General Bulletin: GB2021002

SIII Crane Harness Radio Eliminate Cable Connector

Classification	Modification
Subject:	Installation of Deviated Radio Eliminate Cable Connector
Attn:	IMT Distributors
From:	IMT Technical Support (800-554-4421 or 641-923-4633)
Date:	December 2021
Affected Models:	2021 SIII Telescopic Cranes

A. Connector mounted on the SIII body control panel:

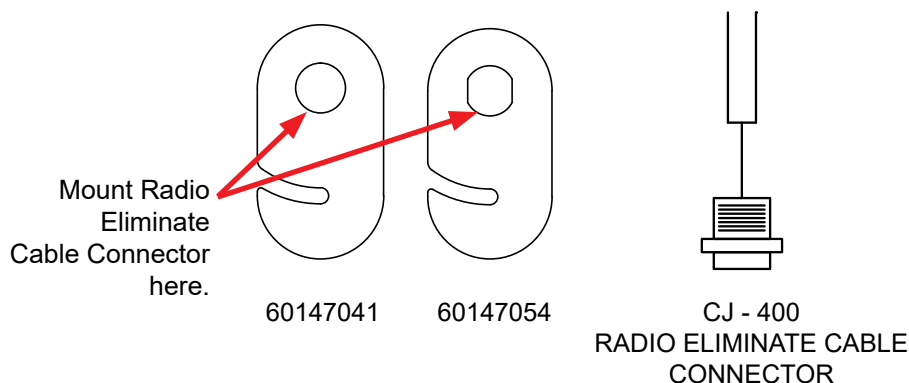
Due to the world-wide supply chain shortages, there is a deviation to the SIII telescopic crane harnesses. The radio eliminate cable connector requires a mounting hole which is different from the standard mounting hole. A matching mounting hole bracket is attached to each deviated harness. Part numbers are 60147041 (Bracket-M12 Unlimited Deviation #1) or 60147054 (Bracket-M12 Unlimited Deviation #2).

1. See step-by-step instructions on page two.
